SOUTHEASTERN WISCONSIN REGIONAL PLANNING COMMISSION

MEMORANDUM

SUBJECT: SOUTHEAST WISCONSIN 2015 LIDAR (SEWI_5)

Appendix

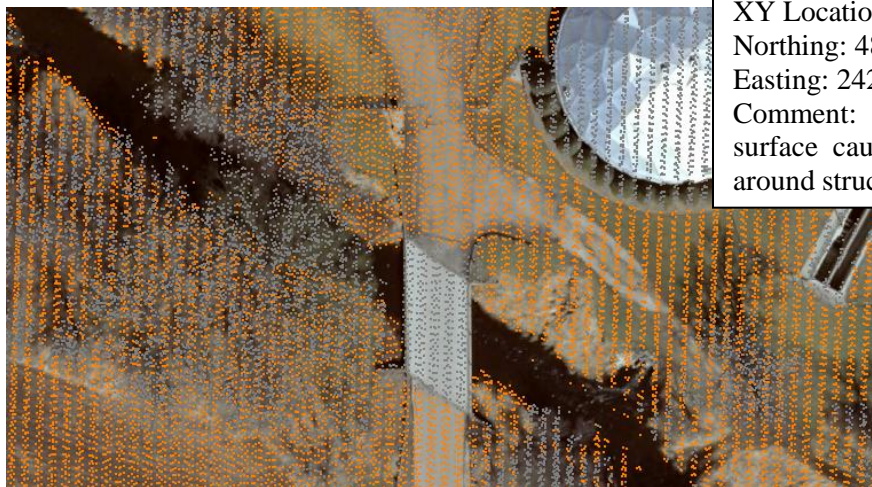
XY Location:
Northing: 488900
Easting: 2422800
Comment: Bridge classified using Classes 1 and 17 (Non-Ground and Overlap Non-Ground)...should be Class 14 (Bridge)

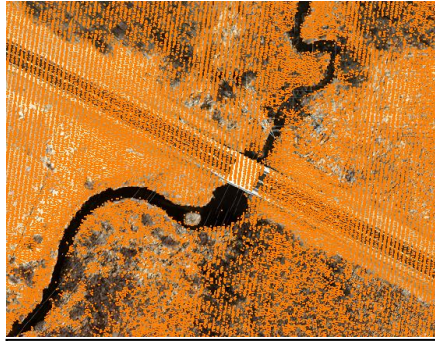
XY Location:
Northing: 485500
Easting: 2428440
Comment: Ground points left in surface causing improper contouring around structure.

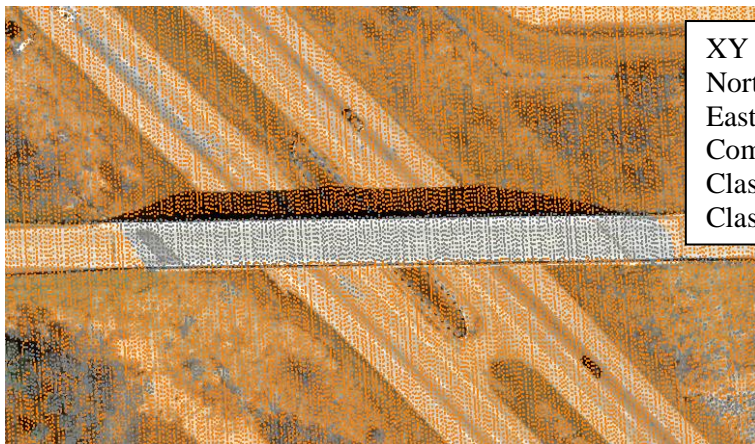
XY Location:
Northing: 502300
Easting: 2513200
Comment: Ground points left in surface causing improper contouring around structure.

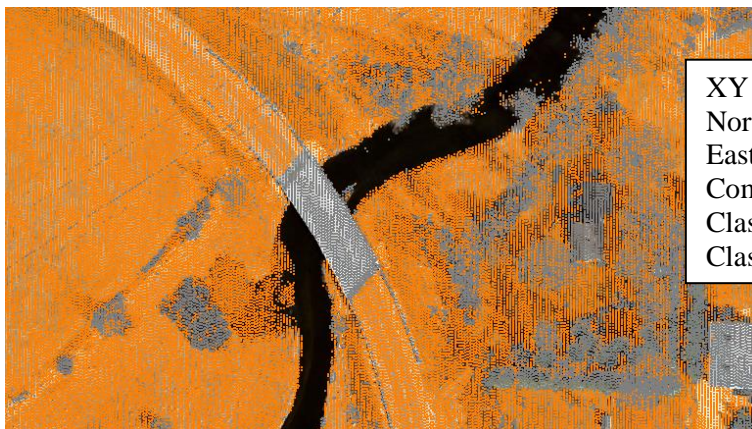
XY Location:
Northing: 477200
Easting: 2476400
Comment: Bridge classified using Class 1 (Non-Ground)...should be Class 14 (Bridge)

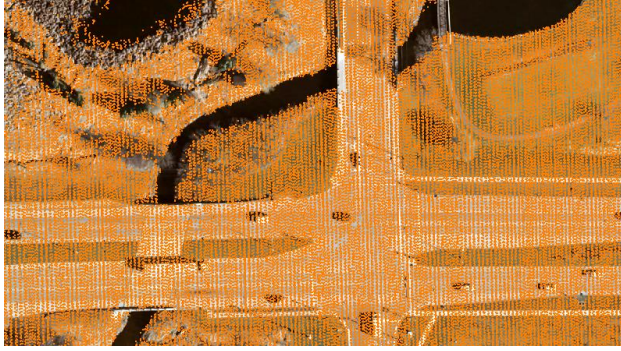
XY Location:
Northing: 495900
Easting: 2511300
Comment: Bridge classified using Class 1 (Non-Ground)...should be Class 14 (Bridge)

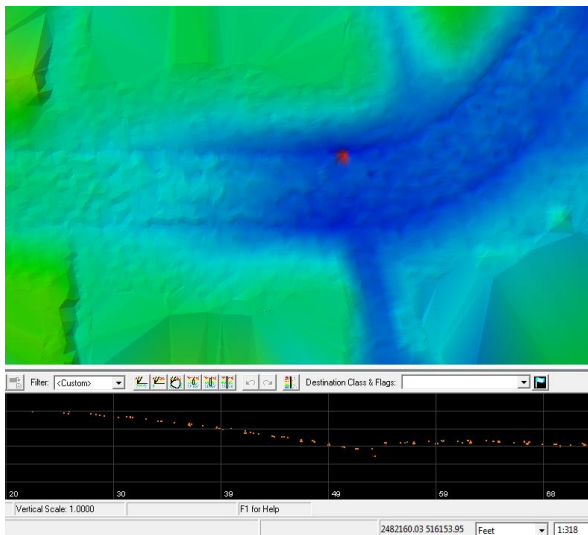
XY Location: Northing: 450600; Easting: 2497600
 Comment: Ground points left in surface causing improper contouring around structure.

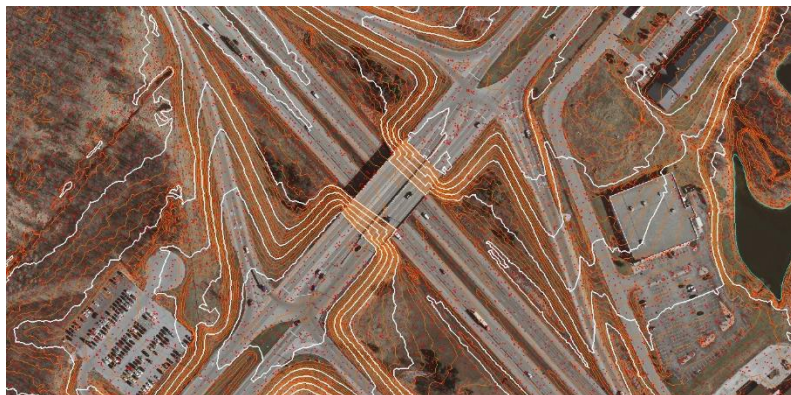
XY Location:
 Northing: 516154
 Easting: 2482167
 Comment: Ground points in storm sewer affecting the road elevation. Also model keypoint has a point in the storm sewer that would also affect the surface elevation

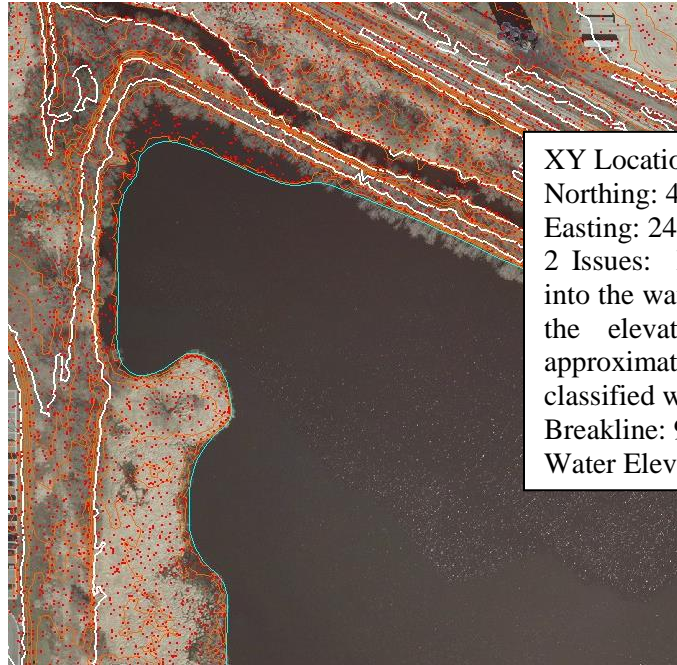
XY Location:
 Northing: 511425
 Easting: 2470591
 Comment: Single Model keypoint in water body.

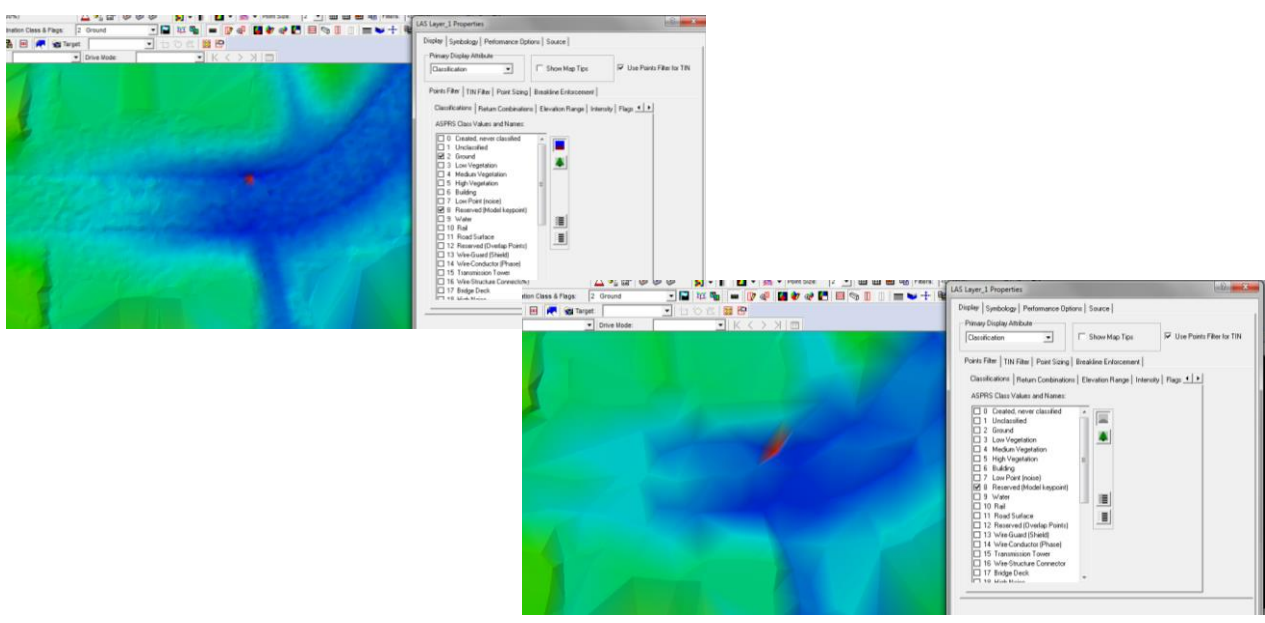
XY Location:
 Northing: 487400
 Easting: 2426200
 2 Issues: Hydro breakline encroaches into the water body significantly. Also, the elevation of the breakline is approximately 1.5 feet lower than the classified water points.
 Breakline: 956.000 feet
 Water Elev. approximately 957.5 feet

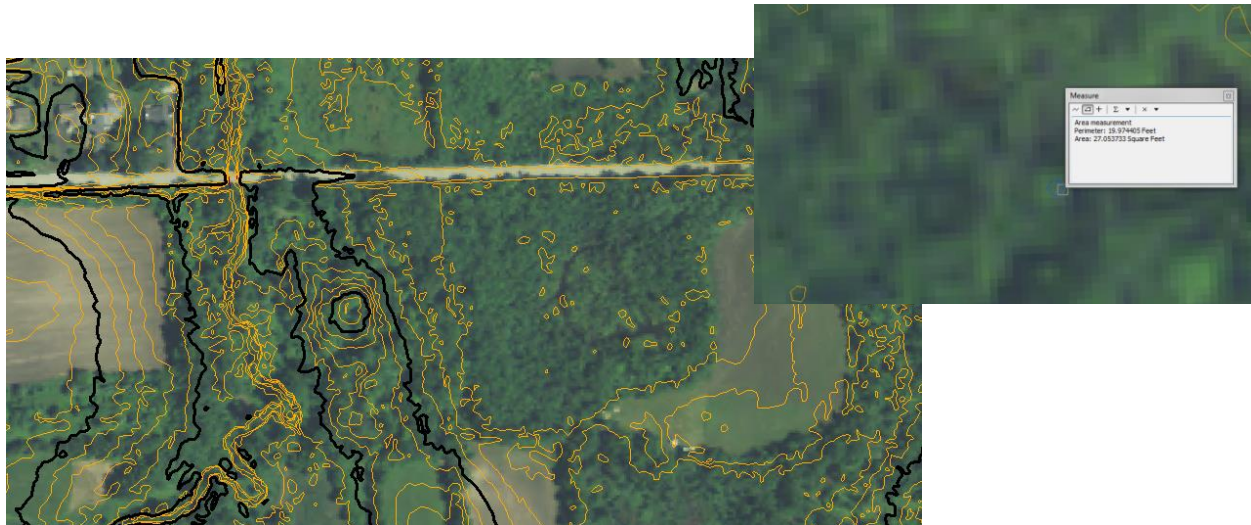
- A zero elevation breakline has been included affecting the contour generation which needs to be removed and new contours generated.

NAD83 Position:
X = 2394009ft; Y=556345ft

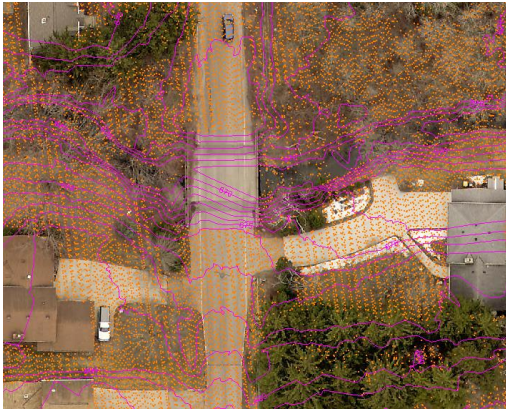
- Overall all hydro breaklines appear to be 0.5 – 1.5 feet lower than expect terrain. See below for screen capture examples demonstrating the inconsistencies. It should be noted that the bridge breaklines are consistent with topology. The hydro breaklines might be a possible indexing related to finalization of the classified LAS files due to Geoid procedures.

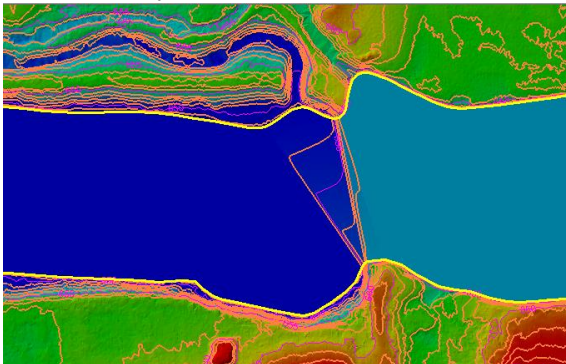
- A few bridge breakline were missed. Below is a screen capture demonstrating the issue when no breakline are used on shorter spans

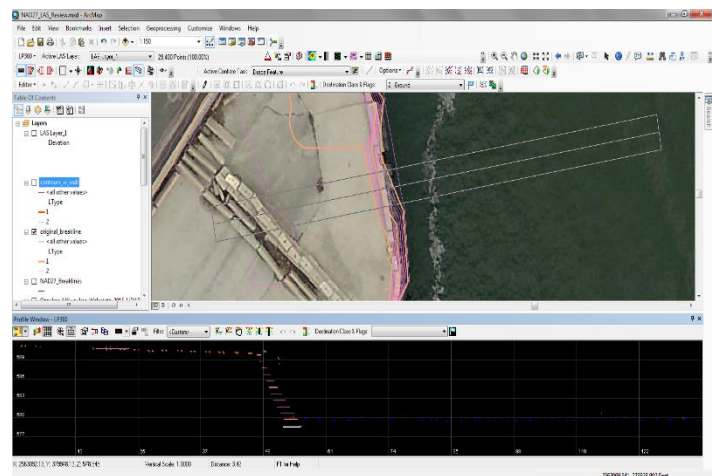
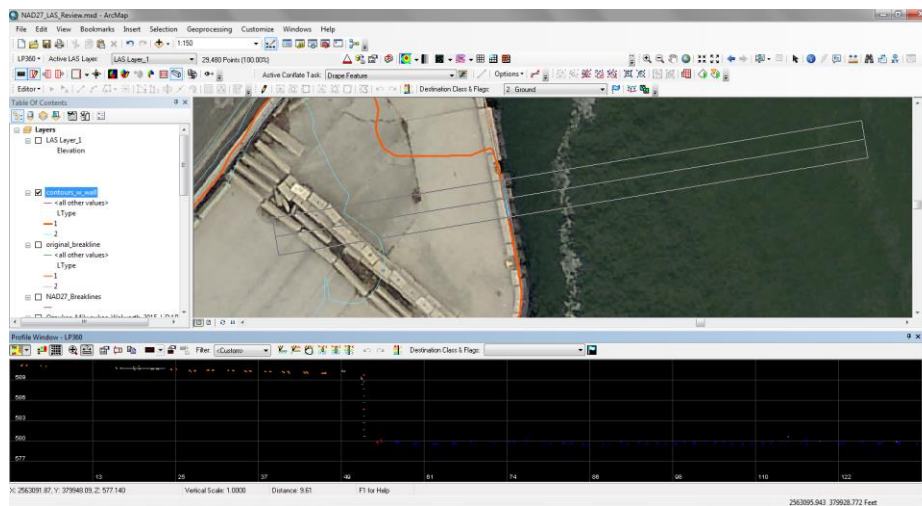
- Breaklines especially near walls have significant issues. The first issue is horizontal alignment accuracy. Most wall breaklines were collected well inside of the wall surface itself (i.e. breakline is placed in the water). The horizontal placement ranges anywhere from 3 – 10 feet off of apparent location which is cause numerous issues on the contour generation. Shown below is a location with both horizontal error and how the contouring looks when the breakline is enforced. The measured horizontal error on this sample below is 4.6 feet. The second major issue is the need to create a second breakline due to the significant vertical change and assurance of proper contouring around these features in meeting National Map Accuracy Standards. This second breakline allows proper enforcement and characterization of the topology around these specific wall features. The screen capture below shows what the contours look around this area. The Commission edited the existing line to locate it at the base of the wall itself and placing the breakline at the water surface of 580.0. The second breakline was created using LP360-retaining wall conflation tool.

- Below demonstrates how the wall contours would look with use of the second breakline and proper enforcement..

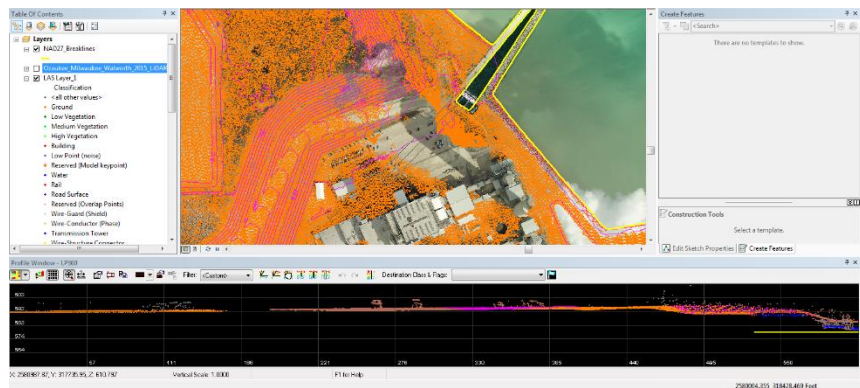
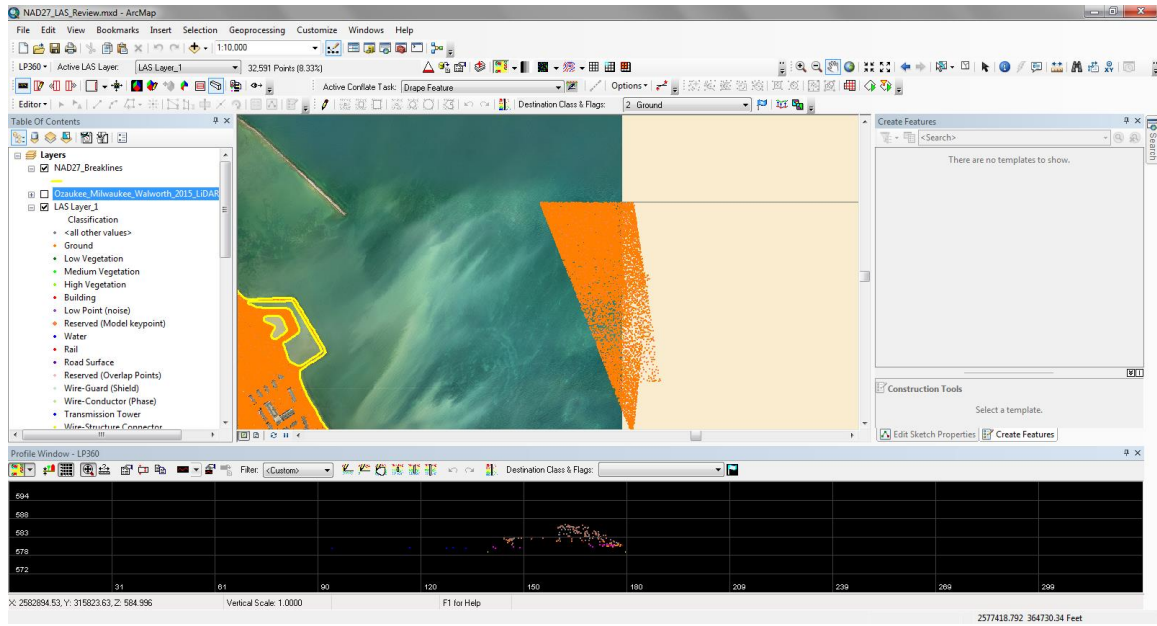
- Missing ground points and model keypoints. Need to put ground points back in surface supporting walls around collected breakline below.

- Missing ground points around power plant. Smoke was causing a major ground obstruction on the primary flight line but the neighboring flight line(s) covered the ground well. Need to re-run ground around plant area to properly classify terrain. This mis-classification edit call was not in the shapefile but location was near the edit call location for ground points along the shoreline wall discussed above.

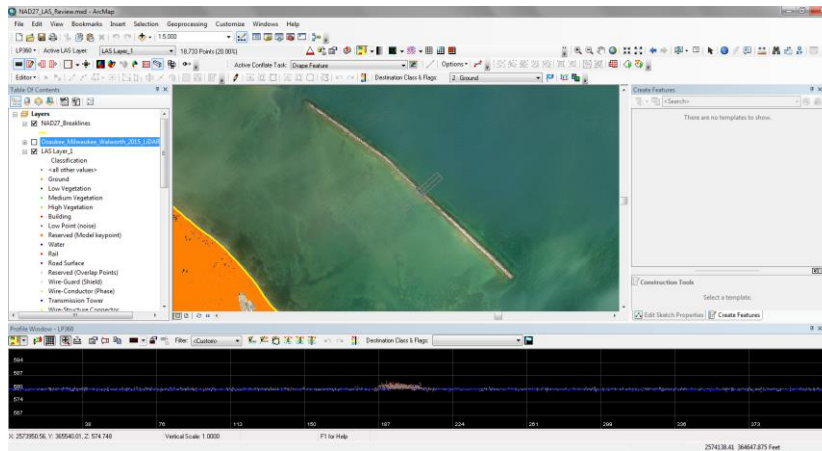
- Water points that were classed as ground. Need to re-classed points to water. These points are the tiles along Lake Michigan shoreline and are well out in the lake

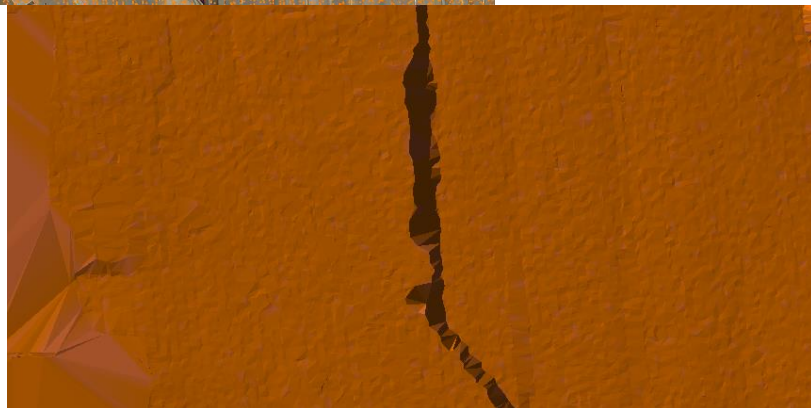
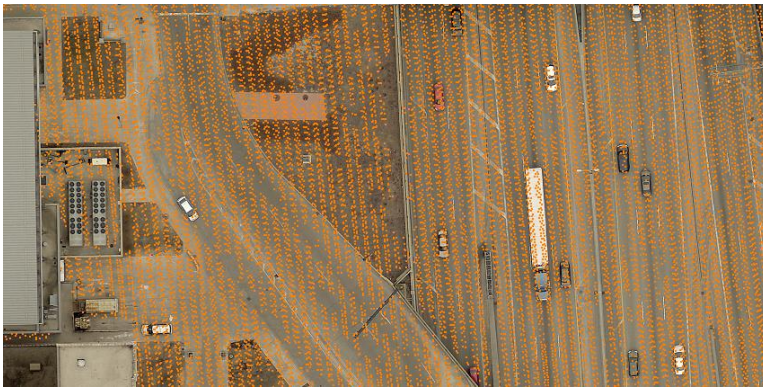
- Ground points missing causing the contouring to be affected.

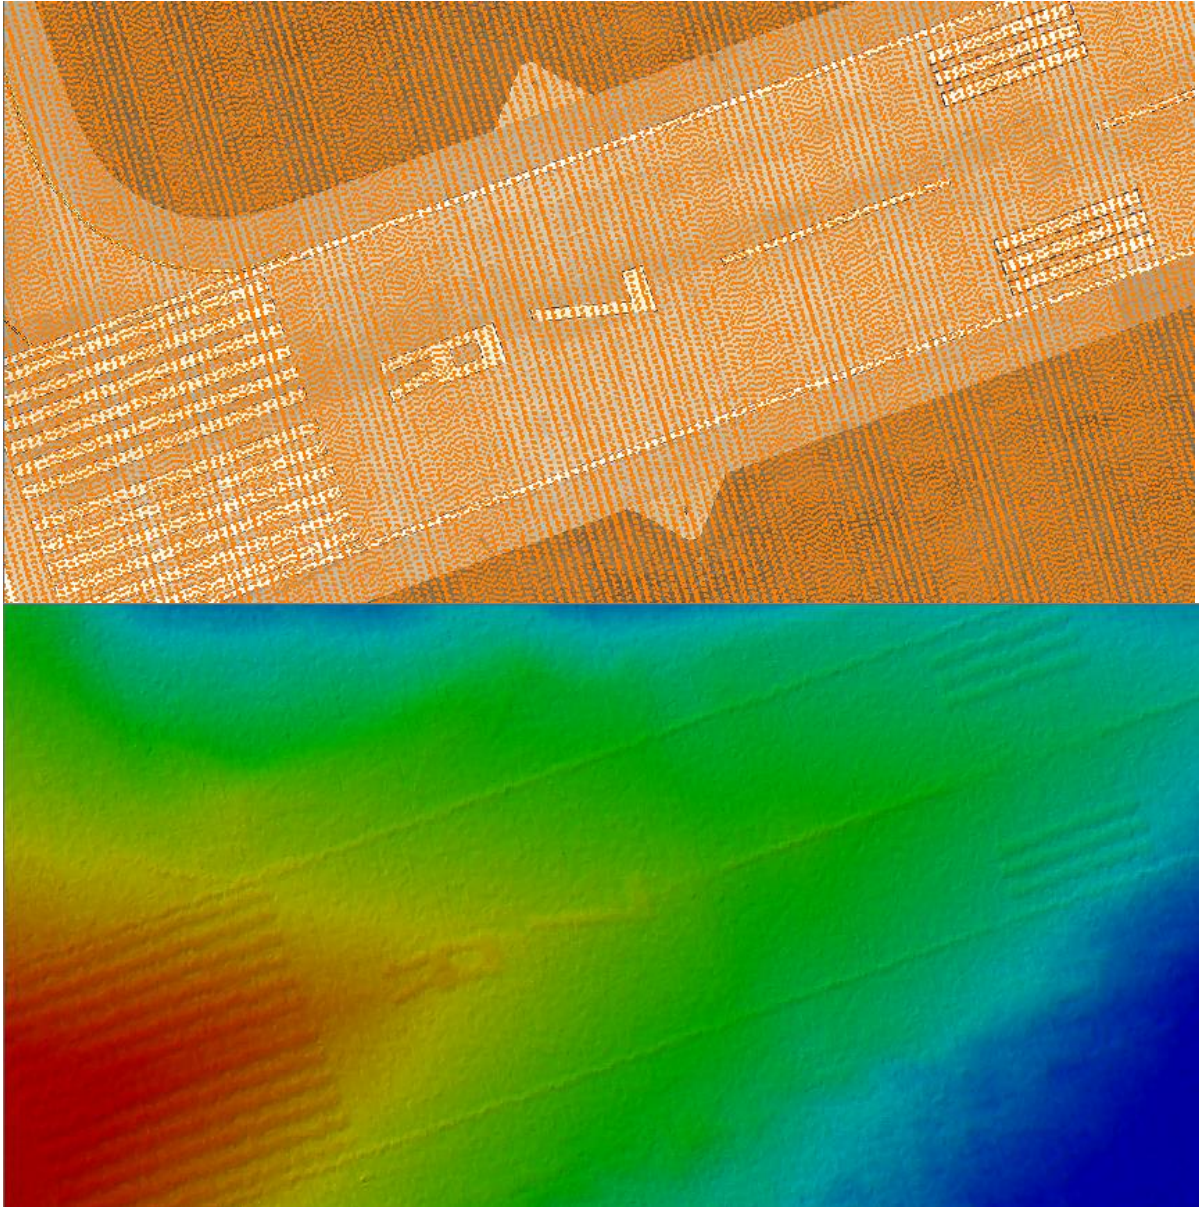
- Missing ground points along a transportation wall that affects contouring and DTM surface modeling. See below regarding a sample effect of the ground macro peeling back the ground points along a vertical feature.

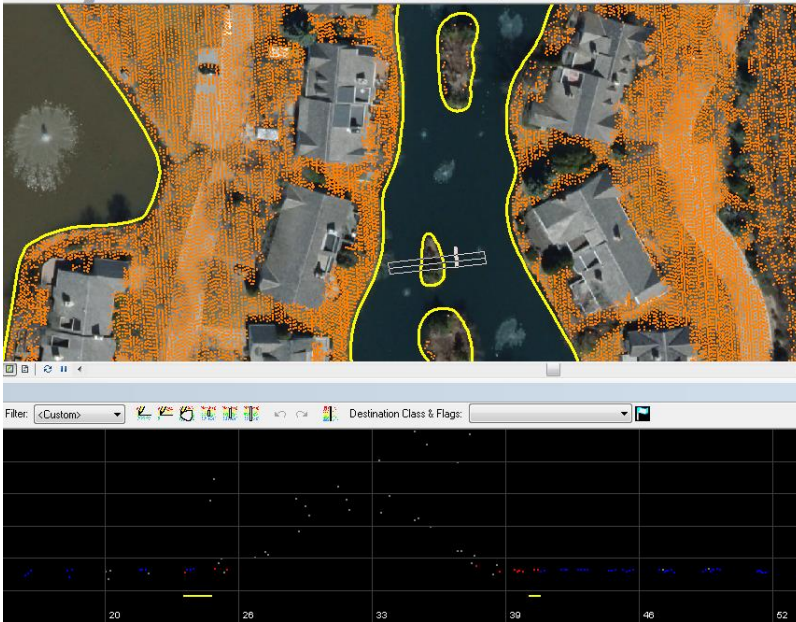
- Runway stripes seem to float above the average ground terrain based on the super reflective surfaces. See below of an example of the runway bias.

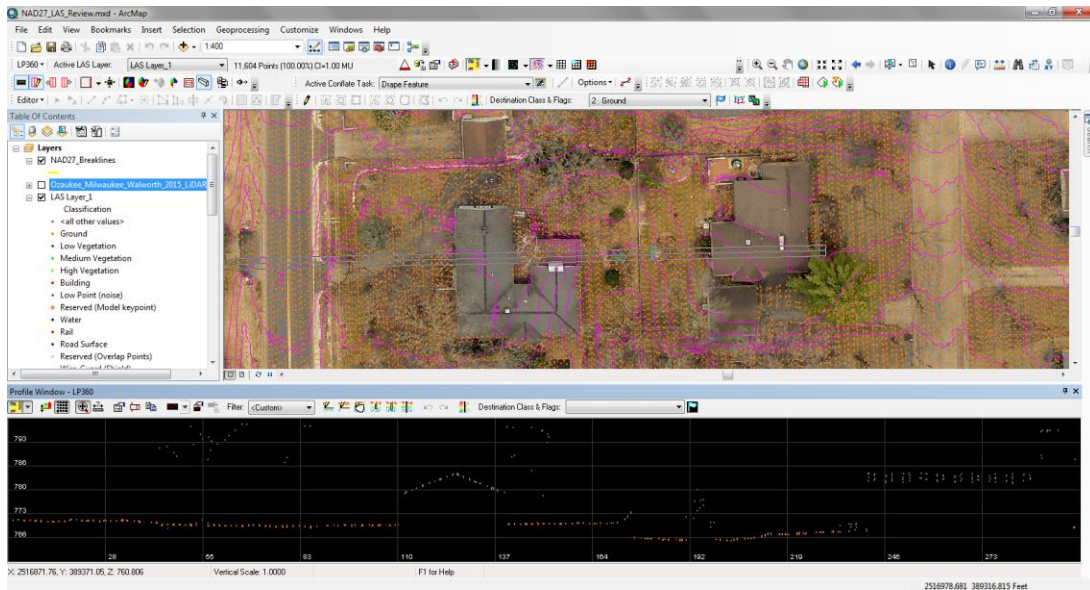
- Missing ground points in island breakline. Breakline capturing an island has been compiled but the ground points are missing. See below for an example.
